MODEL
**2011-2013MY
Sorento (XM)**

NUMBER
041

TECHNICAL SERVICE BULLETIN

SUBJECT: FRONT STRUT AND DUST COVER REPLACEMENT

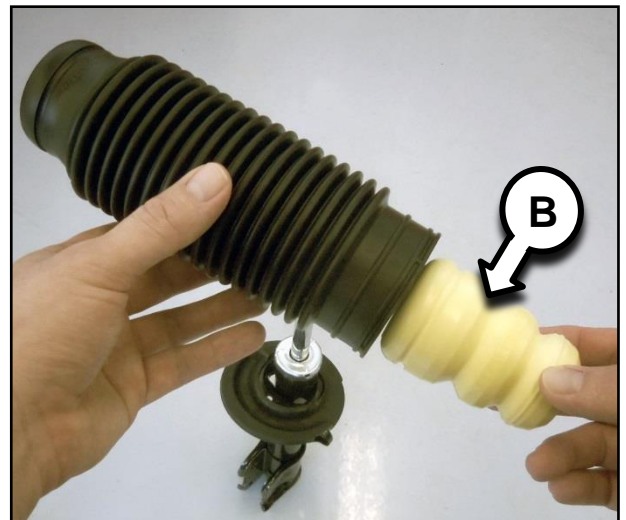
1. Remove and disassemble the front strut assemblies by referring to the service procedures in the applicable Workshop Manual on KGIS.
2. Remove the dust cover (A) from the strut shaft.

3. Remove the bump stop (B) from inside the dust cover.

Discard the dust cover and the strut.

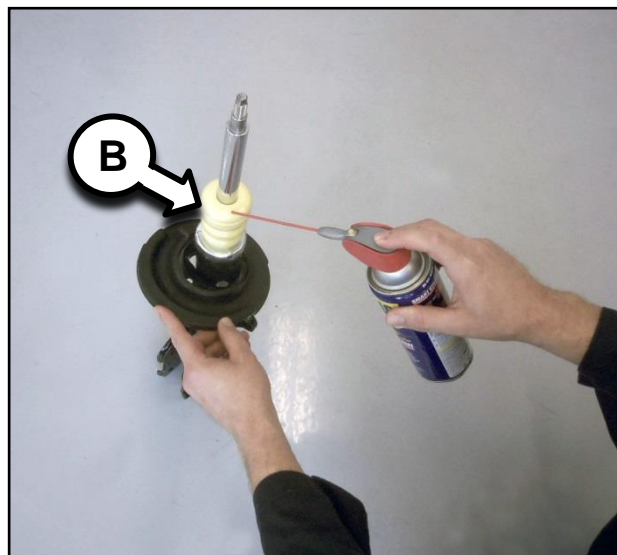
4. Install the bump stop (B) onto the new strut. Make sure to push the bump stop down until it makes contact with the strut body.

Apply a small amount of lubricant around the top of the bump stop in order to allow for easier installation of the dust cover.

5. Install the dust cover onto the bump stop. Make sure the bump stop is properly seated inside the dust cover.

6. Pull the dust cover and bump stop until the bottom lip of the dust cover is slightly below the strut body.
